Access Compliance Report

Public Rights-of-Way

(Curb Ramps)

Intersection ID: N/A	Main Street: WENDOVER_CR	Cross Street: SHARON_RD	Location: SE
ADA ID: 4B9452BD85AF	Ramp Type: Perp	Initial Pass/Fail: Fail	Overall Compliance: No
Severity Score: 46.25			
Codes/Mitigation Info/Possible Solution		Field Measurements/Component Compliance

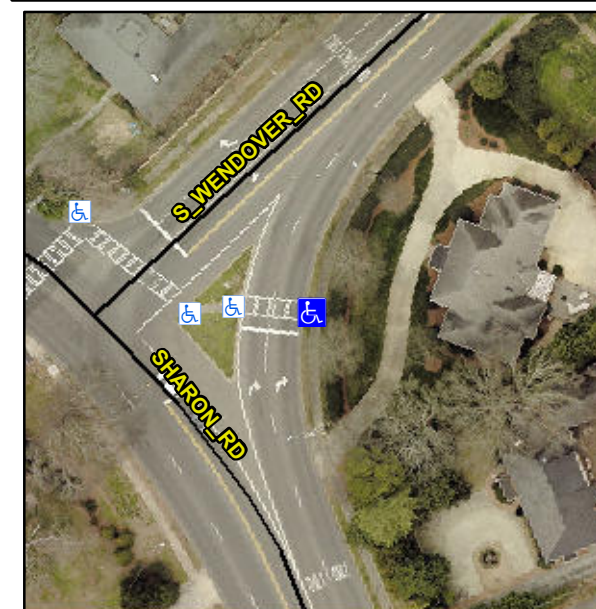
Not Found, R304.5.1, R304.2.2, R304.5.3

Compliance	Description	Data	Compliance	Description	Data
N/A	Ramp Length (in)	56.0	No	Ramp Slope (%)	14.2
No	Ramp Width (in)	38.5	No	Ramp XSlope (%)	6.1
N/A	Flare Type LT	N/A	N/A	Flare Type RT	N/A
N/A	Flare Slope LT (%)	N/A	N/A	Flare Slope RT (%)	N/A
N/A	Flare Traversable LT?	N/A	N/A	Flare Traversable RT?	N/A
N/A	Landing Length (in)	N/A	N/A	DWS Provided?	N/A
N/A	Landing Width (in)	N/A	N/A	DWS Contrast?	N/A
N/A	Landing Slope (%)	N/A	N/A	DWS Length (in)	N/A
N/A	Landing X Slope (%)	N/A	N/A	DWS Full Width?	N/A
N/A	Landing Curb? (Y/N)	N/A	N/A	DWS Offset (in)	N/A
N/A	Shared Landing?	N/A			
N/A	Gutter Ponding?	N/A	N/A	Gutter Slope (%)	N/A
N/A	Gutter Lip Ht (in)	N/A	N/A	Gutter X Slope (%)	N/A
N/A	Painted X Walk1?	Yes	N/A	Painted X Walk2?	N/A
	X Walk 1 Direction	To NW		X Walk 2 Direction	N/A
N/A	X Walk 1 Width (in)	103.0	N/A	X Walk 2 Width (in)	N/A
	X Walk 1 Slope (%)	4.9		X Walk 2 Slope (%)	N/A
	X Walk 1 X Slope (%)	4.2		X Walk 2 X Slope (%)	N/A

Remove & Replace Entire Ramp.
